**CITY OF BLOOMINGTON
PLAN COMMISSION**

December 5, 2016 @ 5:30 p.m.

BLOOMINGTON PLAN COMMISSION
STAFF REPORT
LOCATION: 900-902 E. Cottage Grove Avenue

**BLOOMINGTON PLAN COMMISSION
STAFF REPORT
LOCATION: 323 and 455 S. Westplex Ave.**

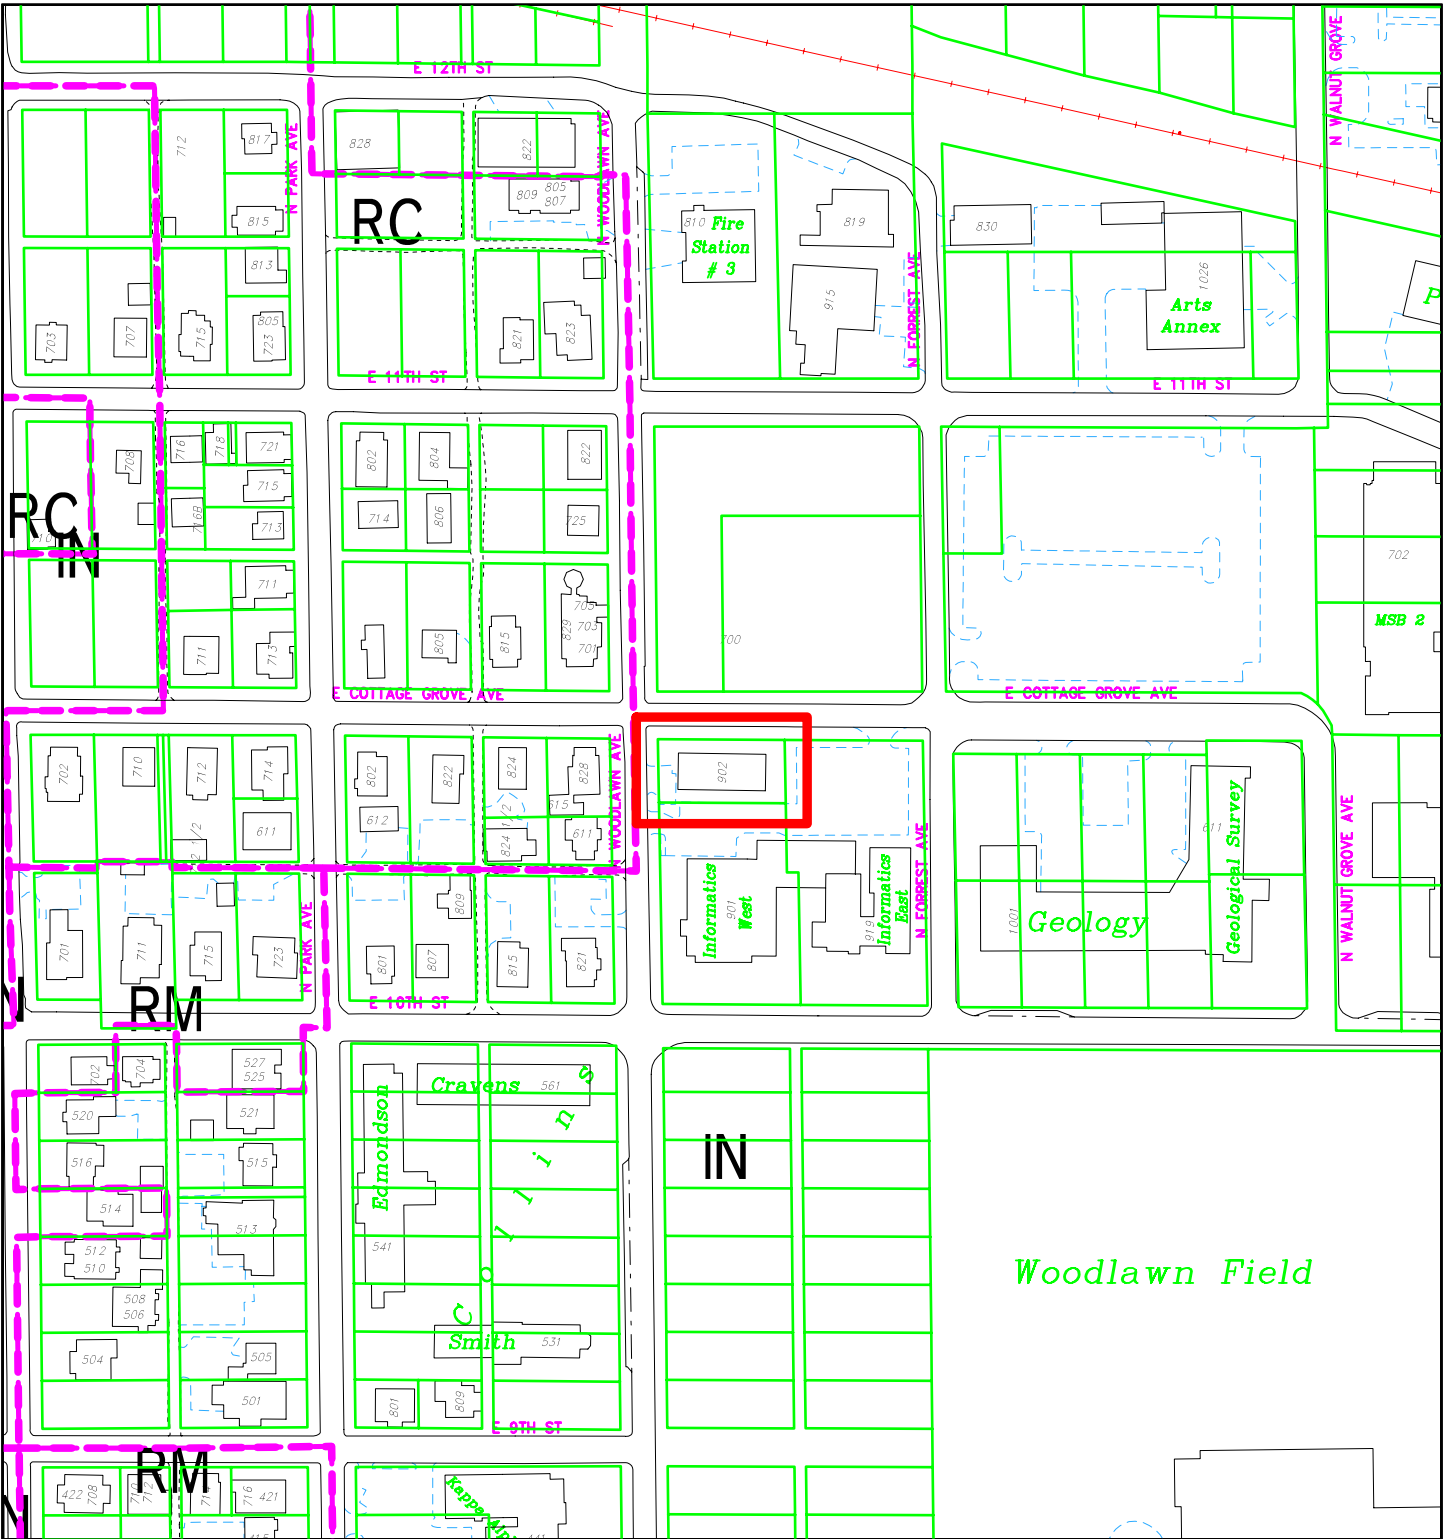
Surrounding Zones and Uses: The property is surrounded on three sides by Institutional (IN) zoned property that is owned and operated by Indiana University. The surrounding IN parcels are part of the larger Indiana University campus. All of the properties on the east side of Woodlawn Avenue from East Atwater Avenue to East 17th Street are zoned IN. The properties directly west of the petition site, on the west side of Woodlawn Avenue, are zoned Residential Core (RC) and contain a single-family residence and a two-unit multi-family residence. There is no RH zoning immediately adjacent to the petition site, or in the surrounding area. The nearest Residential Multifamily (RM) zoning, which is a less dense multifamily zoning, is approximately 360 feet southwest of the petition site, fronting on East 10th Street.

Approval of the rezone would create a non-contiguous island of RH zoning on one property.

CONCLUSION: Staff does not promote rezoning a property to a non-contiguous zone for the purpose of matching the zoning to the existing use. Rezoning the property to a district different than all neighboring property is 'spot zoning' and does not further the goals of either the GPP or the Indiana University Master Plan. The use can continue to operate on the property in its current state as a lawfully non-conforming use without the rezone. The site has never been zoned for multi-family use and the RH zoning district is not the appropriate zone for this site.

THIRD & PATTERSON PLAZA
(RENDERING TO BE UPDATED)

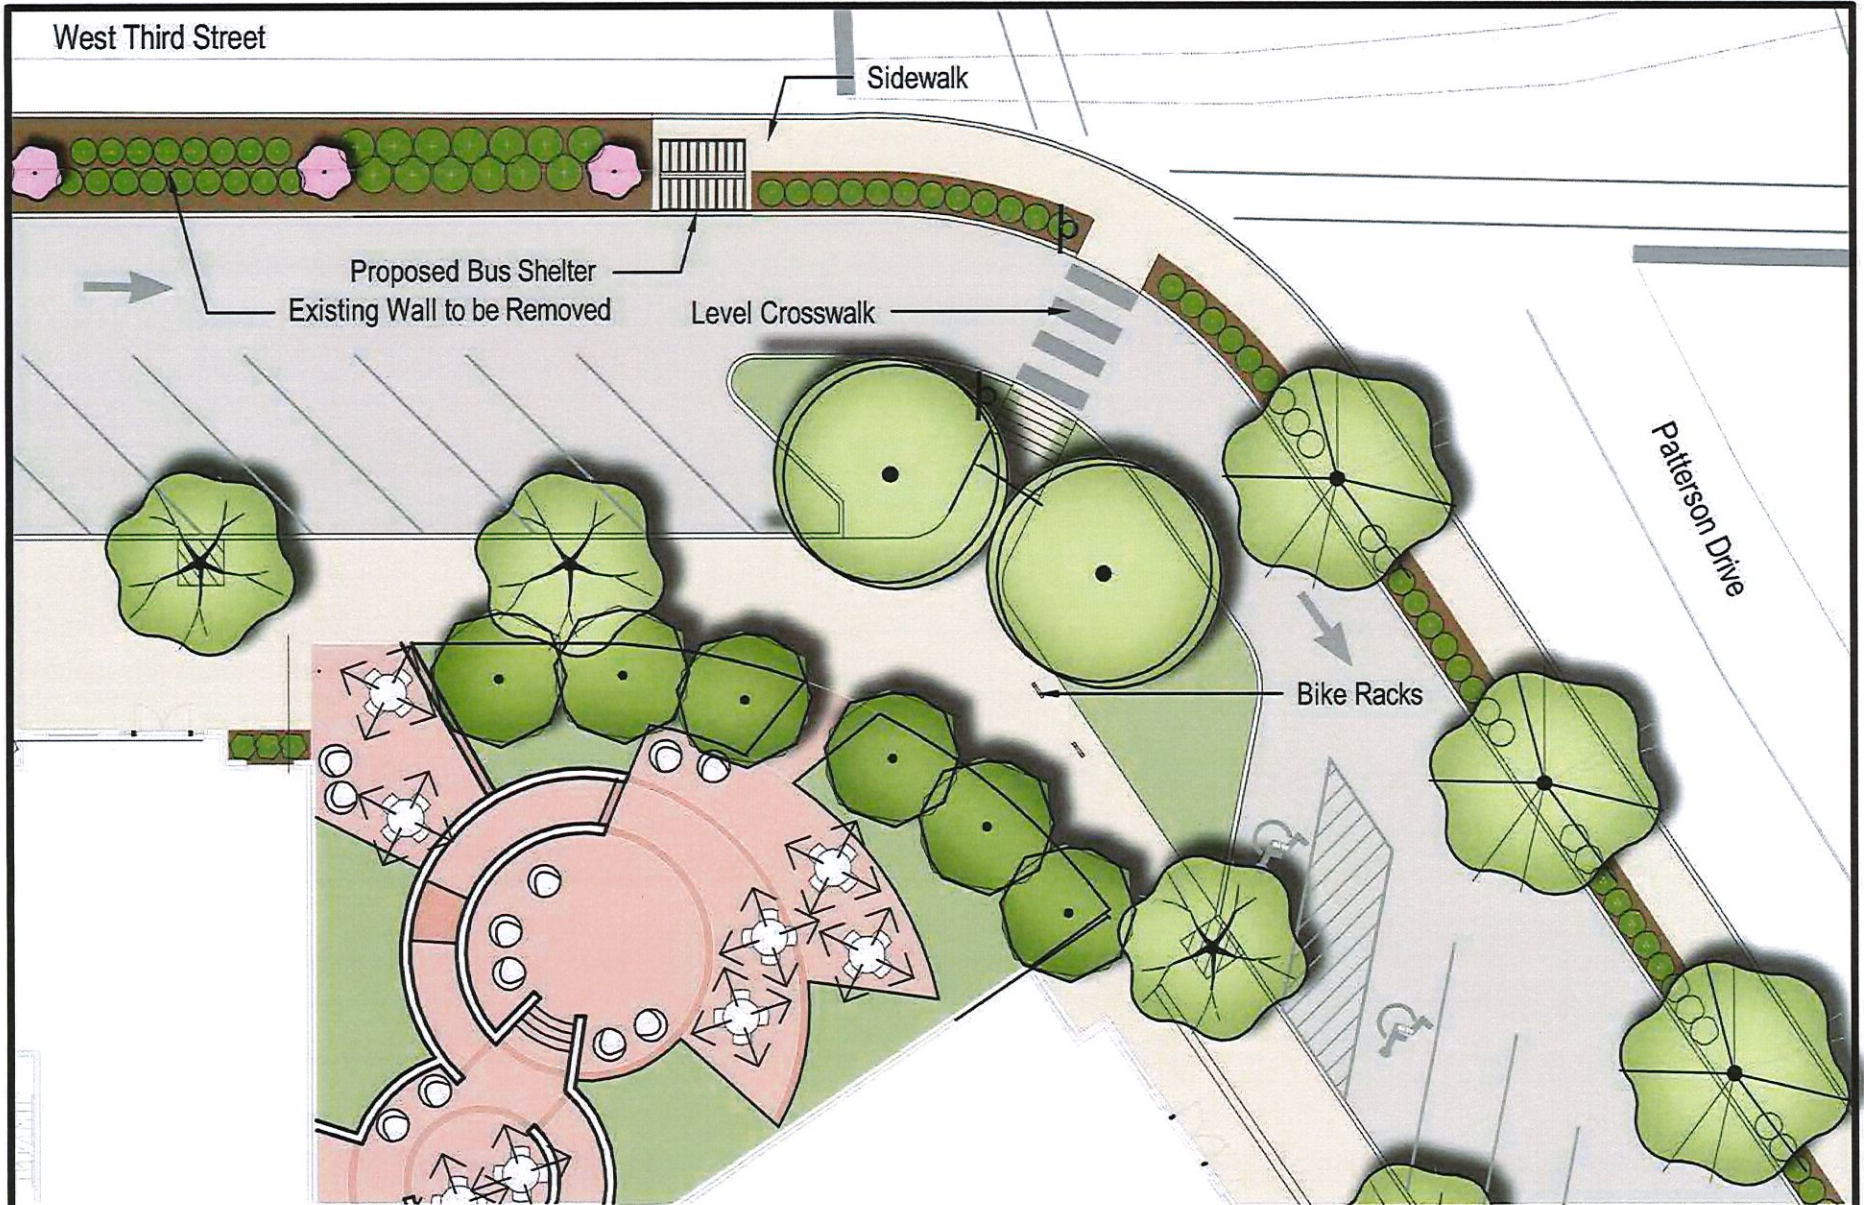
The existing combined curb and sidewalk along 3rd and Patterson will be removed and replaced with a wide plaza and sidewalk on the opposite side of the parking boulevard. This is consistent with the PUD alternative for the parking boulevard. There was discussion at the last meeting about the distance this placed the storefronts to the street. Prior to the meeting, the petitioner intends to provide a cross section drawing showing how these elements align. This sidewalk must be placed in a pedestrian easement to ensure that it is open to the public in perpetuity. This plan also includes a pedestrian crossing of the parking boulevard to access the bus stop and pedestrian crosswalks at the southwest corner of 3rd and Patterson. The petitioner continues to work with staff on the design of this corner and the pedestrian improvements.

- Revised the routing and design of the restored intermittent stream area to achieve more natural, meandering pattern including two new rain garden areas south of the stream before stormwater enters the stream from the parking and building areas.
- Removed culverts under vehicular bridges over stream area and replaced with abutments and walls to better resemble bridges. This also allowed for keeping large existing trees just east of the extended Westplex Drive.
- Developing more information for the traffic safety at Westplex and 3rd Street and new traffic that would turn into the parking drive in front of buildings 2, 3, and 4.
- Revised architecture to better achieve PUD design.
- Added more detail and renderings for the pedestrian plaza area.

PROJECT TITLE:
CREEK RESTORATION PLAN Intermediate Zone

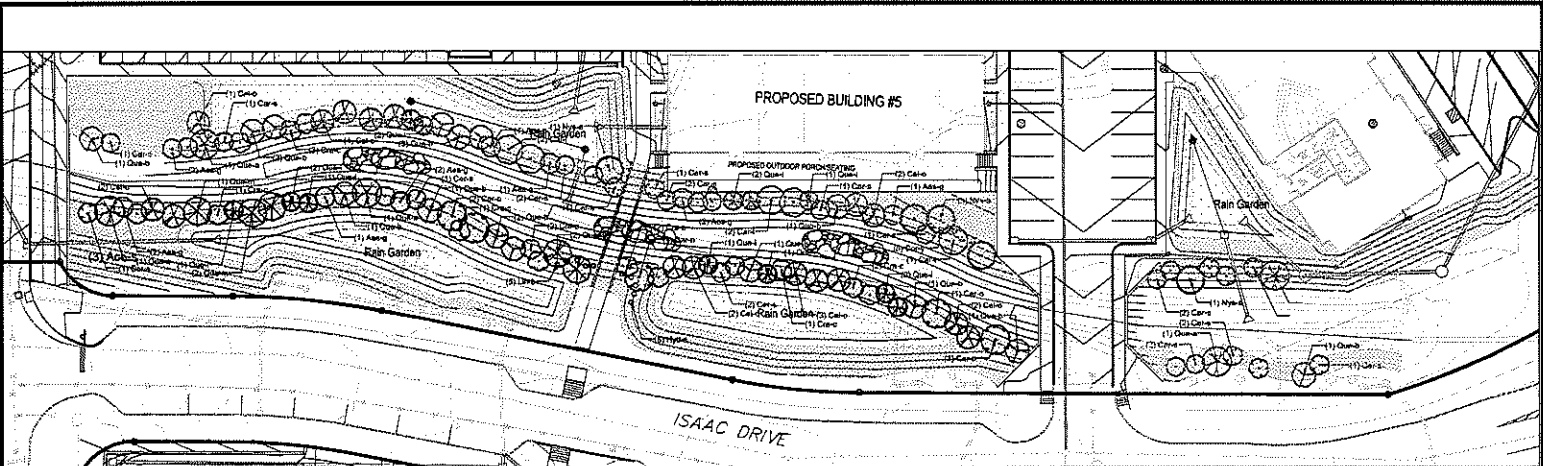
The proposed creek restoration has been dramatically changed since the November meeting. The new plan is in keeping with the design approved in 2011 in terms of plants, maintenance, tree preservation, water quality features, and culvert design. The Environmental Commission report does not note any needed changes to the design.

The Landscape Plan needs some revisions. The EC recommends that the Petitioner and staff continue working to make these corrections.
